SERVICE LETTER 191

FIRE BOSS WATER SCOOP SWITCH REPLACEMENT

Aircraft Makes/Model(s):	Float Model(s):	Compliance: As required	By: MAB
AT-802 & AT-802A	10000A	Part Number: 1009904	Approved: SDW
		Date : 6/11/2019	Revision: B

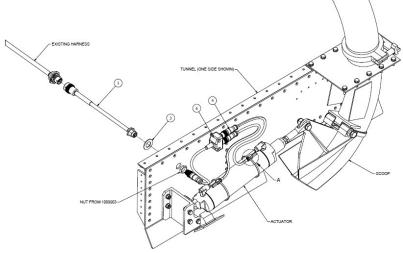
The originally installed water scoop switch assemblies may have issues with water contamination of the various connectors. The new method utilizes parts with molded connectors more suitable for prolonged water exposure.

Remove existing water scoop switches and replace with new style switch assemblies as per this Service Letter.

1. Gain access to water scoop system baggage area from aft bulkhead panel. Then remove water scoop tunnel covers.

- 2. Remove hydraulic actuator assembly from tunnel to facilitate installation of new switches.
- 3. Disconnect existing Canon plug from scoop tunnel side wall. Remove and discard switch harness from hydraulic scoop actuator.
- 4. Connect Cannon plug to new adapter harness (1009903).
- 5. Zip tie up to existing wires/hydraulic lines.

- If not already done, mark the Splitter 2 Branch 4 Wire (U0163-11) with "DN" at the #1 position, and "UP" at the #2 position. The "UP" Switch will be towards the aft end of the float and the "DN" switch will be towards the fwd end of float.

- 7. Open up the diameter of the Washer (NAS1149D0963J) to 19/32, to fit Adapter receptacle.
- 8. Remove Rubber O-Ring from rear mount receptacle of Harness Adapter. Replace with modified Washer.

- Insert Rear Mount Receptacle of Harness Adapter (1009903) through tunnel access hole from outside. Secure
 with nut and taper facing inwards (helps to center connector in larger hole). Assemble wet with PR-1422 or
 equivalent.

- 10. Ensure connector end and internal area remain free of sealant.
- Remove left hand screws from Inductive Magnet Sensors (S4685792). Mount switches on scoop hydraulic actuator using ASB-6 Straps (M6965106) and Cord Sets (S693351). See Detail A.

- 12. Re-install hydraulic actuator assembly with previously removed hardware.
- 13. Connect corresponding switches to splitter. Connect splitter to bulkhead connector.

- Secure Splitter Harness and Switch assemblies with Plastic Cable Tie (PLT-25-M).
